WISCONSIN DEPARTMENT OF TRANSPORTATION

IH-94 NORTH-SOUTH RECONSTRUCTION, MILWAUKEE COUNTY:

ROAD SAFETY AUDIT

June 2008

Southbound, between Howard Avenue and Mitchell Interchange

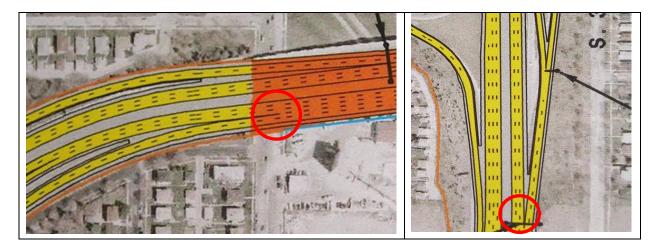
The Howard Avenue southbound ramp joins IH-94 on a curve (*red arrow*). Vehicles traveling on IH-94 may not expect vehicles joining the freeway on a curve. Also, vehicles entering the freeway may have difficulty merging into adjacent lanes to travel in the desired lane necessary to continue on IH-94.

Vehicles entering southbound on Howard Avenue are required to change three lanes to continue on IH-94. Three lane changes in a short distance increases driver frustration and weaving which may lead to sideswipe and rear-end collisions.

A fourth lane is added south of the Howard Avenue Bridge *(blue arrow).* This additional lane increases the need for lane changes along the Plainfield Curve.

Expected Crash Types:	weaving, rear-end collisions
Expected Frequency:	occasional
Expected Severity:	low
Risk Rating:	C (moderate risk level)

Consider four lanes instead of five between Howard Avenue and Mitchell Interchange

Removing the added lane south of Howard Avenue will decrease the number of lane changes needed to remain on IH-94. An optional two-lane exit at westbound IH-894 may also be implemented to provide three lanes on IH-94 and two lanes on the ramp. Implementing four lanes instead of five lanes between Howard Avenue and Mitchell Interchange will reduce the number of lane changes needed, to continue on IH-94, from three to two.

Northbound IH-94 Volume and Level of Service at Howard Avenue

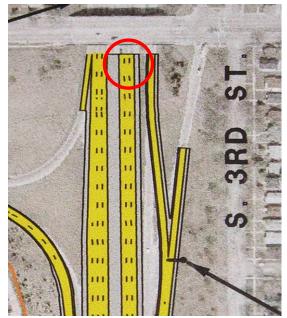
The projected volume of 6,120 veh/hr exceeds the three lane capacity at Howard Avenue. The projected volumes north from IH-94 may also include an additional 500 veh/hr during the AM peak hour. The LOS (level of service) is projected to be an "E" indicating the increase in vehicle delay.

The bottleneck at Howard Avenue increases congestion and vehicles may begin to back into the Plainfield Curve. Vehicles traveling through the Plainfield Curve may not expect back-up beyond the curve and therefore have insufficient time to react to slower speeds, resulting in rear-end collisions.

Expected Crash Types:	weaving, rear-end collisions
Expected Frequency:	frequent
Expected Severity:	low
Risk Rating:	D (significant risk level)

Eastbound IH-894 to northbound IH-94

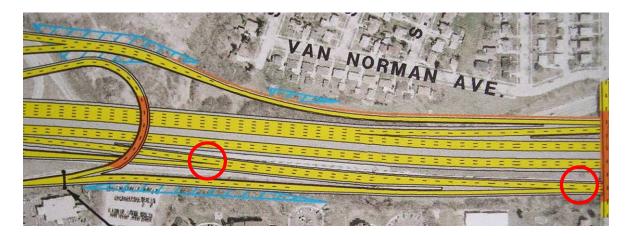
Two successive add-lanes from 27th Street exist on eastbound IH-894 to northbound IH-94. The add-lanes merge further downstream prior to the next add-lane resulting in a shift in traffic at separate locations in close proximity to each other.

Expected Crash Types:	weaving, rear-end collisions
Expected Frequency:	occasional
Expected Severity:	low
Risk Rating:	C (moderate risk level)

Consider consolidating the two 27th Street eastbound on-ramps

Consolidating the two 27th Street eastbound on-ramps would eliminate an add-lane and a merge that through vehicles would have to otherwise navigate through. This would decrease the number of merging conflict points within close proximity of each other.

Drop one lane at Layton Avenue instead of IH-94 Downtown Milwaukee

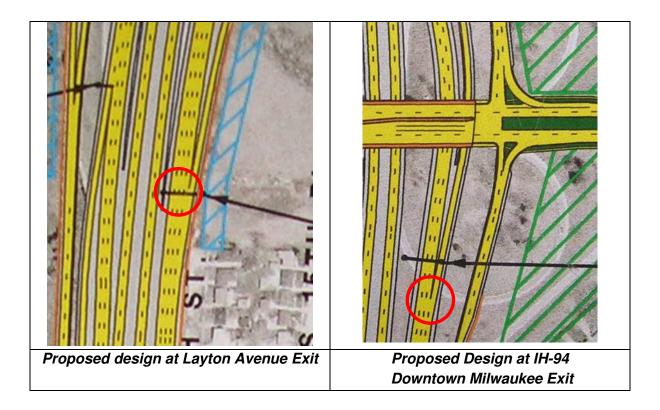
A four-lane weave section is designed on northbound IH-94 along a distance of about 2,000 feet between Grange Avenue and Layton Avenue. Depending on what lane a vehicle is traveling in, a two-lane or three-lane change is needed for vehicles exiting off of IH-94 to exit onto Layton Avenue.

weaving, rear-end collisions
frequent
low
D (significant risk level)

Consider a two-lane optional exit to Layton Avenue and a one-lane optional exit to IH-94 Downtown Milwaukee. A lane drop at Layton Avenue instead of IH-94 Downtown Milwaukee would reduce weaving by eliminating a necessary lane change.

Tight diamond traffic operations

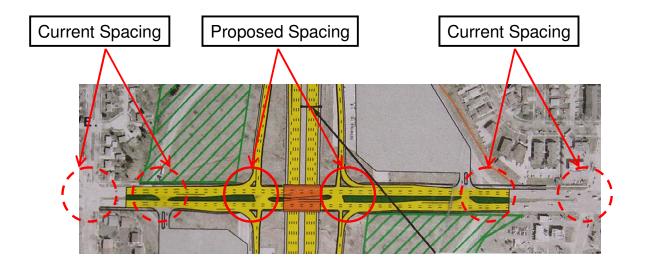
The tight diamond interchange design allows greater distance between the ramp terminal and the adjacent cross street, eliminating queues into the intersection. By providing greater spacing between the ramp terminal and the adjacent cross street, the proposed spacing between the signals at the ramp terminals are closely spaced (*shown below*).

The proposed design provides limited space between tight diamond signals which may result in queues and congestion at the ramp terminals instead of the adjacent intersection. Queues may also back-up into the freeway resulting in sudden braking on a high-speed arterial, increasing the likelihood of rear-end collisions.

Synchro files were reviewed and some inconsistencies noted:

- Left-turn and right-turn volumes may have been transposed
- Level of Service "F" existed on some of the approaches
- Storage area geometrics did not match the proposed plans

rear-end, weaving, left-turn, crossing collisions
frequent
low
D (significant risk level)

Review Synchro files

Review Synchro files and results to ensure that tight diamond signal operations will be efficient and that queues from the turning lanes will not back into through lanes. Include all the affected nearby cross-street intersections in the Synchro analysis.

Consider improved spacing between ramp terminals by providing relatively equal spacing between the signals at the ramp terminals and between the ramp terminal and adjacent intersection. Improved spacing would improve safety and operations by reducing congestion and queues.

6.2 Note 2: Accommodating Cyclists and Pedestrians at Tight Diamonds

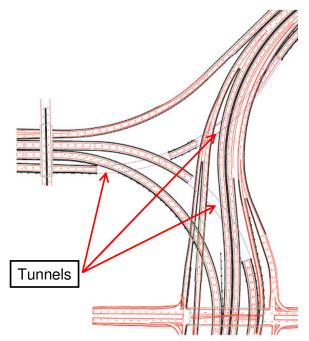
Cyclists and pedestrians may be present at tight diamond interchanges, due to surrounding developments and future growth. Accommodating cyclists and pedestrians with adequate facilities is important to minimize the risk of crashes involving vulnerable road users.

Review path continuity and facilities at Ryan Road, Drexel Avenue, Rawson Avenue, College Avenue, and Layton Avenue. The proposed design should include a complete and continuous network of sidewalks near all tight diamond interchanges. These improvements are expected to improve comfort and safety for non-motorized road users.
